## SB-10041407-5638

SI B12 16 11  
Engine Electrical Systems

This Service Information bulletin supersedes SI B12 16 11 dated August 2011.

**N55 Engine Failsafe - FC 120308 Boost Pressure Control, Plausibility: Pressure Too Low Stored in DME Fault Memory**

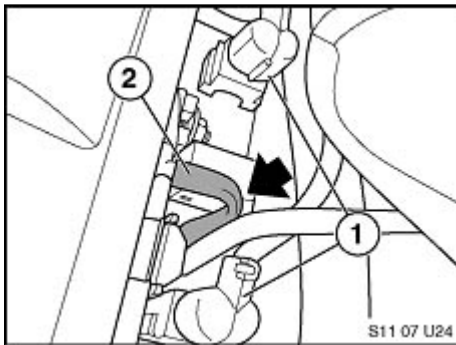
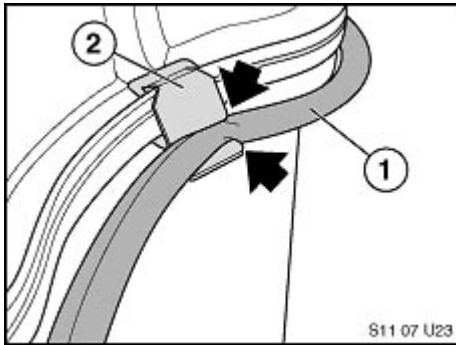
- Perform a quick inspection of all turbocharger boost control vacuum hoses; a slightly collapsed vacuum hose could lead to intermittent boost faults, or boost faults occurring only under heavy acceleration demands.

|  | <ol style="list-style-type: none"> <li>1. Restricted vacuum hose</li> <li>2. Retaining clip</li> </ol> |

1. Vacuum solenoid
2. Kinked or restricted vacuum supply hose

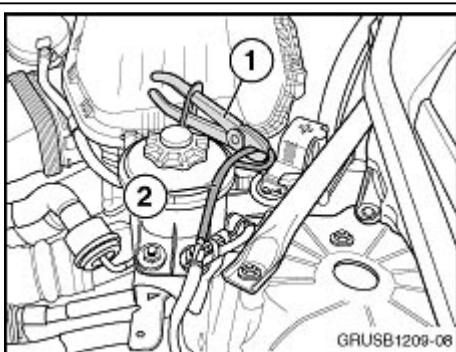
- Using a vacuum gauge can be very helpful in diagnosing a vehicle with intermittent boost faults. Although the problem may not be present long enough to set a boost fault, the gauge may show a hint of a deteriorating vacuum level that could ultimately lead to an effective repair. Connecting the vacuum gauge at the vacuum actuator with a “tee” connection will determine the integrity of the vacuum supply (compare values to the attachment). Erratic operation of the vacuum gauge is a hint that a control problem is present; comparing the gauge movement to another vehicle will help determine whether a problem is present.
- On models equipped with an exhaust flap, isolate or disconnect the vacuum supply to the exhaust flap to eliminate a leaking or a defective vacuum solenoid. This can be done very easily by blocking the hose located near the right front strut tower.

1. Suitable tool used to block the supply hose
2. Vacuum supply hose for the exhaust flap solenoid
